Access Compliance Report

Public Rights-of-Way

Intersection ID: 28169	Main Street: JAMES_RICHARD_DR	Cross Street: N/A	Location: SW
ADA ID: 9694686EB029	Ramp Type: Perp	Initial Pass/Fail: Fail	Overall Compliance: No
Severity Score: 17.5			
Codes/Mitigation Info/Possible Solution		Field Measurements/Component Compliance

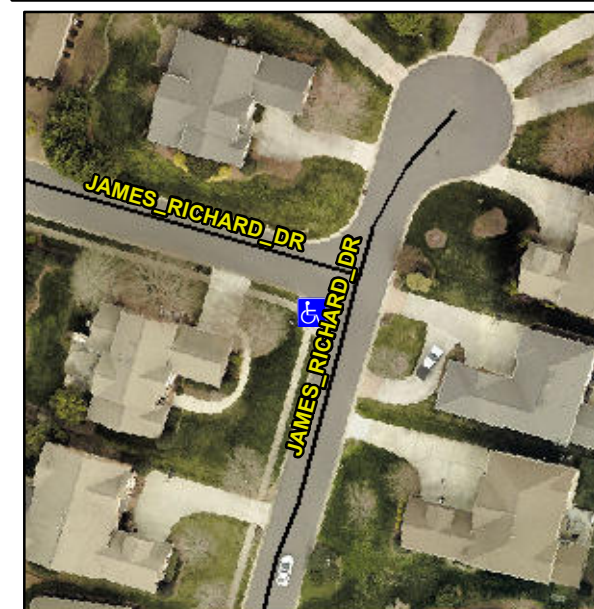
Not Found, R304.5.1

Compliance	Description	Data	Compliance	Description	Data
N/A	Ramp Length (in)	47.5	Yes	Ramp Slope (%)	7.1
No	Ramp Width (in)	35.0	Yes	Ramp XSlope (%)	1.6
N/A	Flare Type LT	N/A	N/A	Flare Type RT	N/A
N/A	Flare Slope LT (%)	N/A	N/A	Flare Slope RT (%)	N/A
N/A	Flare Traversable LT?	N/A	N/A	Flare Traversable RT?	N/A
N/A	Landing Length (in)	N/A	N/A	DWS Provided?	N/A
N/A	Landing Width (in)	N/A	N/A	DWS Contrast?	N/A
N/A	Landing Slope (%)	N/A	N/A	DWS Length (in)	N/A
N/A	Landing X Slope (%)	N/A	N/A	DWS Full Width?	N/A
N/A	Landing Curb? (Y/N)	N/A	N/A	DWS Offset (in)	N/A
N/A	Shared Landing?	N/A			
N/A	Gutter Ponding?	N/A	N/A	Gutter Slope (%)	N/A
N/A	Gutter Lip Ht (in)	N/A	N/A	Gutter X Slope (%)	N/A
N/A	Painted X Walk1?	No	N/A	Painted X Walk2?	N/A
	X Walk 1 Direction	To E		X Walk 2 Direction	N/A
N/A	X Walk 1 Width (in)	N/A	N/A	X Walk 2 Width (in)	N/A
	X Walk 1 Slope (%)	3.5		X Walk 2 Slope (%)	N/A
	X Walk 1 X Slope (%)	6.2		X Walk 2 X Slope (%)	N/A

Remove & Replace Entire Ramp.
